Access Compliance Report

Public Rights-of-Way

Intersection ID: 8886	Main Street: LAKEWOOD_AV	Cross Street: ROZZELLES_FERRY_RD	Location: S
ADA ID: 06DB15EADD39	Ramp Type: PerpDiag	Initial Pass/Fail: Fail	Overall Compliance: No
Codes/Mitigation Info/Possible Solution		Field Measurements/Component Compliance	
Severity Score: 8.75

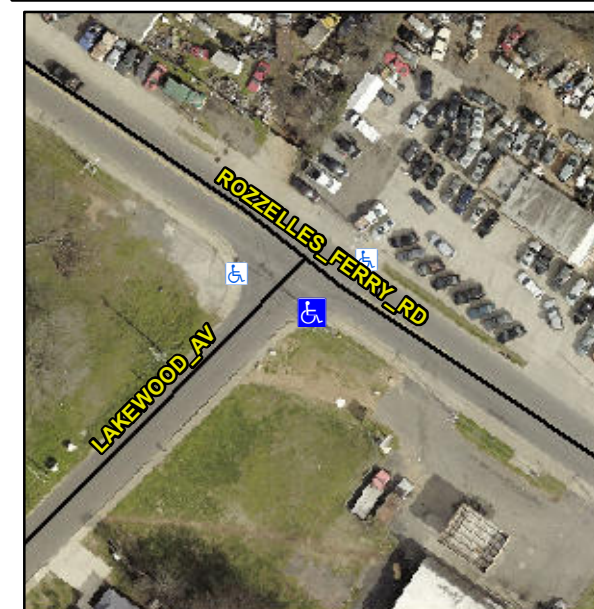
Not Found, R304.5.1

Compliance	Description	Data	Compliance	Description	Data
N/A	Ramp Length (in)	58.0	Yes	Ramp Slope (%)	7.5
No	Ramp Width (in)	43.0	Yes	Ramp XSlope (%)	1.1
N/A	Flare Type LT	N/A	N/A	Flare Type RT	N/A
N/A	Flare Slope LT (%)	N/A	N/A	Flare Slope RT (%)	N/A
N/A	Flare Traversable LT?	N/A	N/A	Flare Traversable RT?	N/A
N/A	Landing Length (in)	N/A	N/A	DWS Provided?	N/A
N/A	Landing Width (in)	N/A	N/A	DWS Contrast?	N/A
N/A	Landing Slope (%)	N/A	N/A	DWS Length (in)	N/A
N/A	Landing X Slope (%)	N/A	N/A	DWS Full Width?	N/A
N/A	Landing Curb? (Y/N)	N/A	N/A	DWS Offset (in)	N/A
N/A	Shared Landing?	N/A			
N/A	Gutter Ponding?	N/A	N/A	Gutter Slope (%)	N/A
N/A	Gutter Lip Ht (in)	N/A	N/A	Gutter X Slope (%)	N/A
N/A	Painted X Walk1?	No	N/A	Painted X Walk2?	No
	X Walk 1 Direction	To NE		X Walk 2 Direction	To NW
N/A	X Walk 1 Width (in)	N/A	N/A	X Walk 2 Width (in)	N/A
	X Walk 1 Slope (%)	5.3		X Walk 2 Slope (%)	3.6
	X Walk 1 X Slope (%)	1.5		X Walk 2 X Slope (%)	2.2

Remove & Replace Curb Ramp With Two New Directional Ramps or Equivalent.
